ADDENDUM NO. 4

DATE: February 16, 2018
FROM: City of Grand Junction Purchasing Division
TO: All Offerors
RE: Las Colonias Business Park Phase I and Phase IA IFB-4476-18-DH

LAS COLONIAS BUSINESS PARK
PHASE 1
Addenda 4 Valve Location Plan

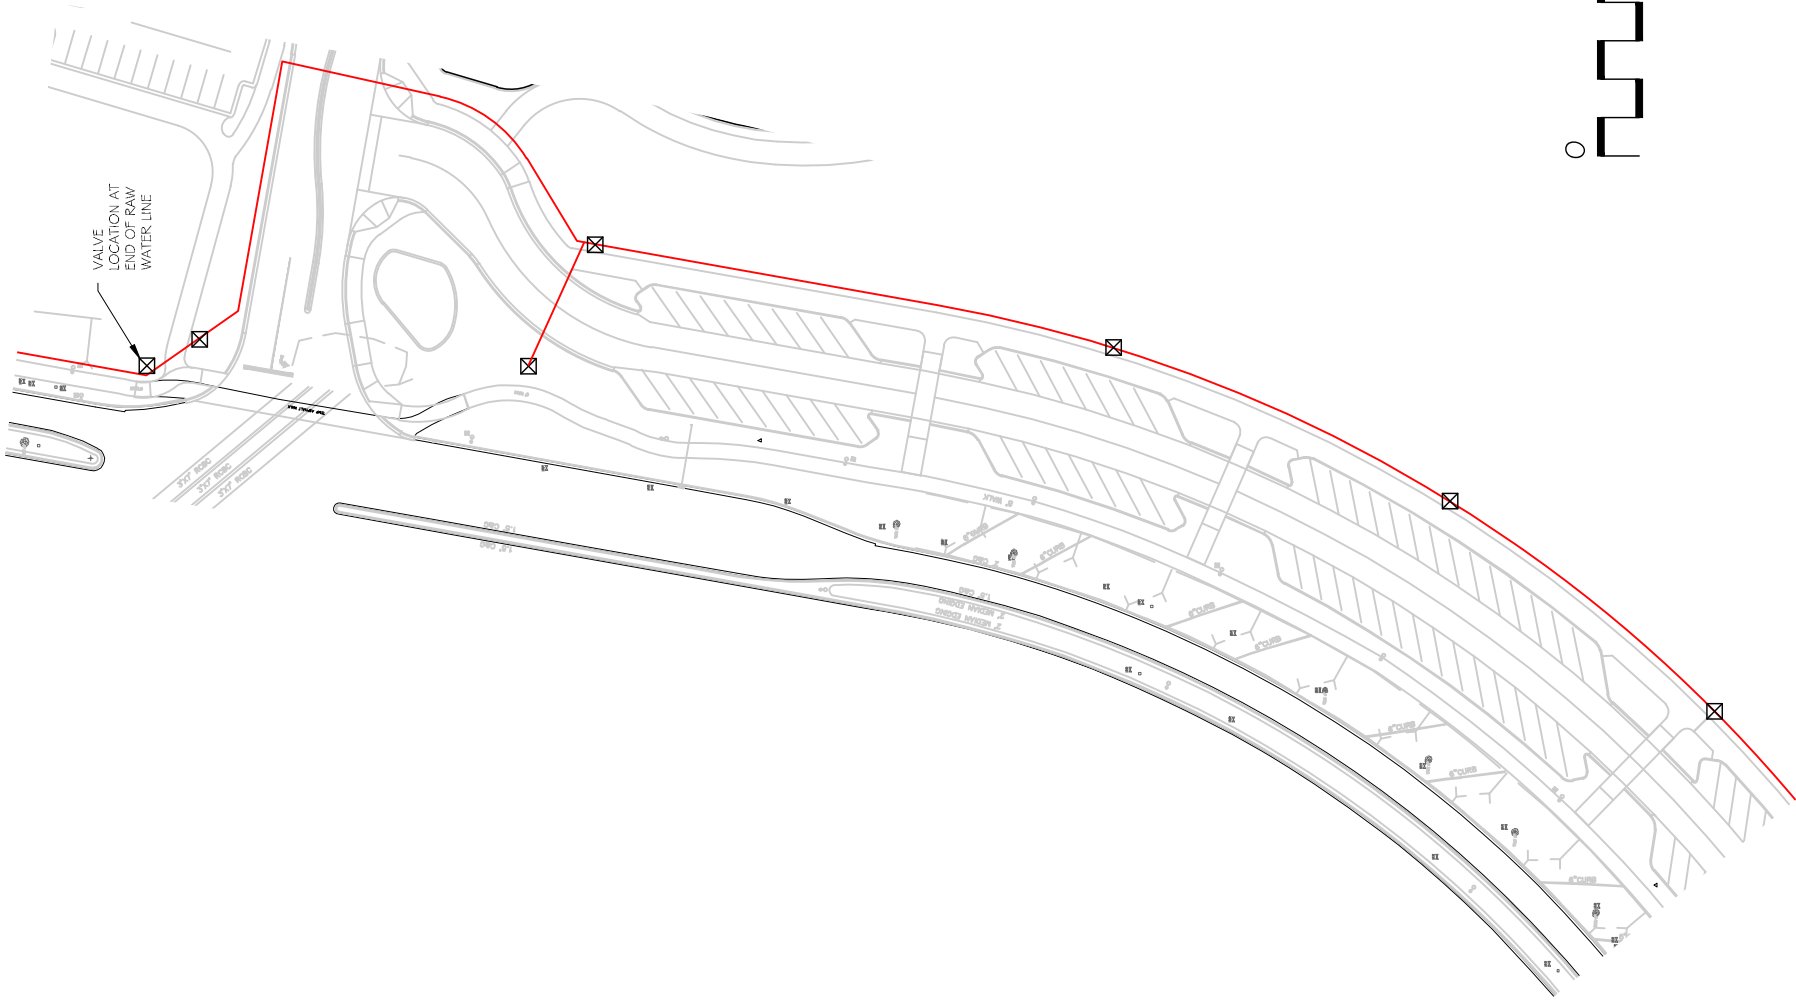
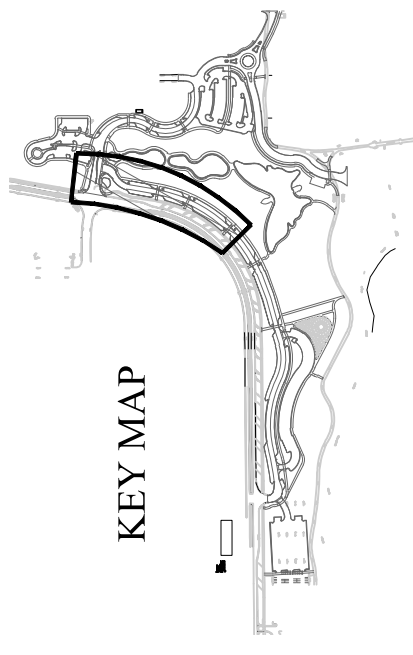
13. **6" Raw Water Line Appurtenances** – The lineal foot cost for installation of the 6" C-900 raw water line shall include appurtenances shown on attached Valve Location Plan Sheets 1 and 1a.

- 3"x 6" Schedule 40 Tee or Harco Saddle – 18 EA.
 - 3" CL 200 PVC Riser (approx. 2' ea.) – +/- 36 LF.
 - 3" PVC Cap – 18 EA.
 - 10" Dia. Valve Box – 18 EA.

- Maxicom Irr. Control Wire – 3,472 LF.
